# Access Compliance Report

Intersection ID: 13899		Main Street: HAWKINS_ST		Cross Street: WEST_BV		Location: NE			
ADA ID: 451692FC60E9		Ramp Type: PerpDiag		Initial Pass/Fail: Fail		Overall Compliance: No		Severity Score: 22.5	
Codes/Mitigation Info/Possible Solution				Field Measurements/Component Compliance

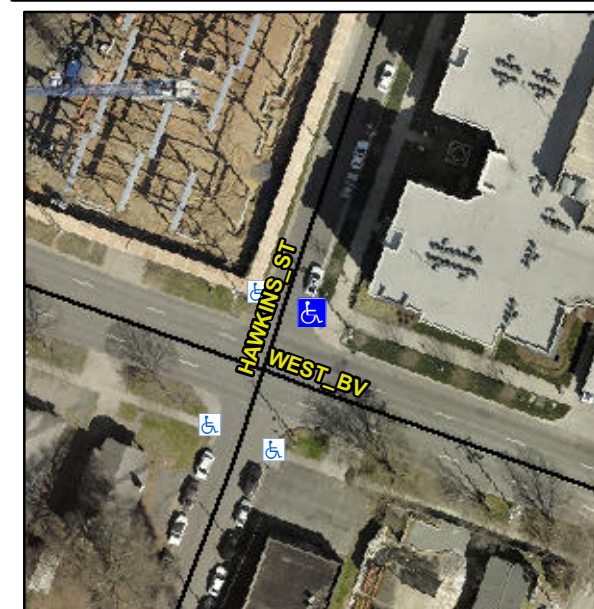
**R304.5.1, R304.2.2, R304.5.3**

Compliance	Description	Data	Compliance	Description	Data
N/A	Ramp Length (in)	122.0	No	Ramp Slope (%)	9.8
No	Ramp Width (in)	44.5	No	Ramp XSlope (%)	2.1
N/A	Flare Type LT	N/A	N/A	Flare Type RT	N/A
N/A	Flare Slope LT (%)	N/A	N/A	Flare Slope RT (%)	N/A
N/A	Flare Traversable LT?	N/A	N/A	Flare Traversable RT?	N/A
N/A	Landing Length (in)	N/A	N/A	DWS Provided?	N/A
N/A	Landing Width (in)	N/A	N/A	DWS Contrast?	N/A
N/A	Landing Slope (%)	N/A	N/A	DWS Length (in)	N/A
N/A	Landing X Slope (%)	N/A	N/A	DWS Full Width?	N/A
N/A	Landing Curb? (Y/N)	N/A	N/A	DWS Offset (in)	N/A
N/A	Shared Landing?	N/A			
N/A	Gutter Ponding?	N/A	N/A	Gutter Slope (%)	N/A
N/A	Gutter Lip Ht (in)	N/A	N/A	Gutter X Slope (%)	N/A
N/A	Painted X Walk1?	No	N/A	Painted X Walk2?	No
	X Walk 1 Direction	To W		X Walk 2 Direction	To S
N/A	X Walk 1 Width (in)	N/A	N/A	X Walk 2 Width (in)	N/A
	X Walk 1 Slope (%)	2.8		X Walk 2 Slope (%)	4.5
	X Walk 1 X Slope (%)	1.1		X Walk 2 X Slope (%)	0.8

**Remove & Replace Curb Ramp With Two New Directional Ramps or Equivalent.**
